**Historical Architectural Review Board  
COA Final Review Sheet**

**HDC-2023-00004**

**Address: 735 Oak Street**

**Proposal: Install solar panels**

Site plan.  
(Applicant)

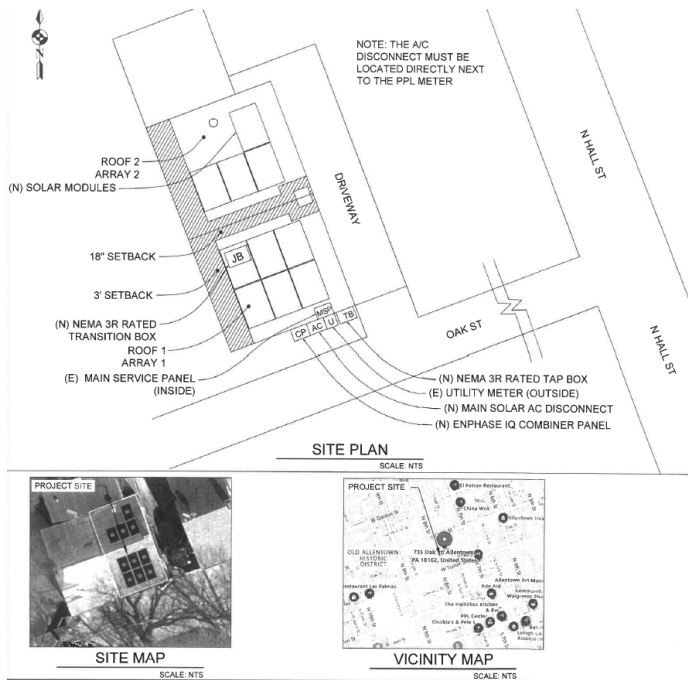
The 6-panel solar array at the front slope would have a 5'-9" setback from the front façade with a 3' setback from the side façade where the private driveway is located. The solar panels would project 6" off the roof and would likely be visible from Oak Street. Staff recommends installing a mock-up of the proposed array at this location to determine visibility. The solar panels should be inconspicuous from the public right-of-way to comply with the guidelines. Staff also suggests that the disconnect and associated utilities be moved off the front façade to a less conspicuous location, if possible.

Approval, provided a mockup shows that the array on the front roof slope is inconspicuous from Oak Street, with the staff to review details, pursuant to Chapter 3, Section 3.10 Solar Energy and Energy Improvements.

Array layout.  
(Applicant)

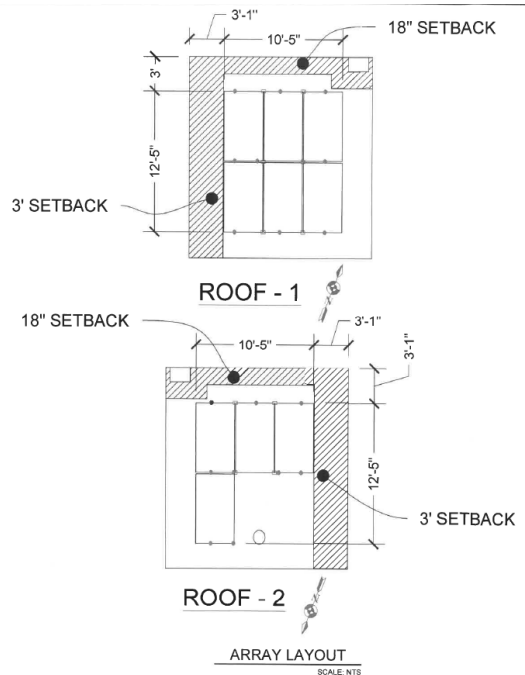
Staff finds that the solar array proposed at the rear would not be visible from a right-of-way and complies with the guidelines.
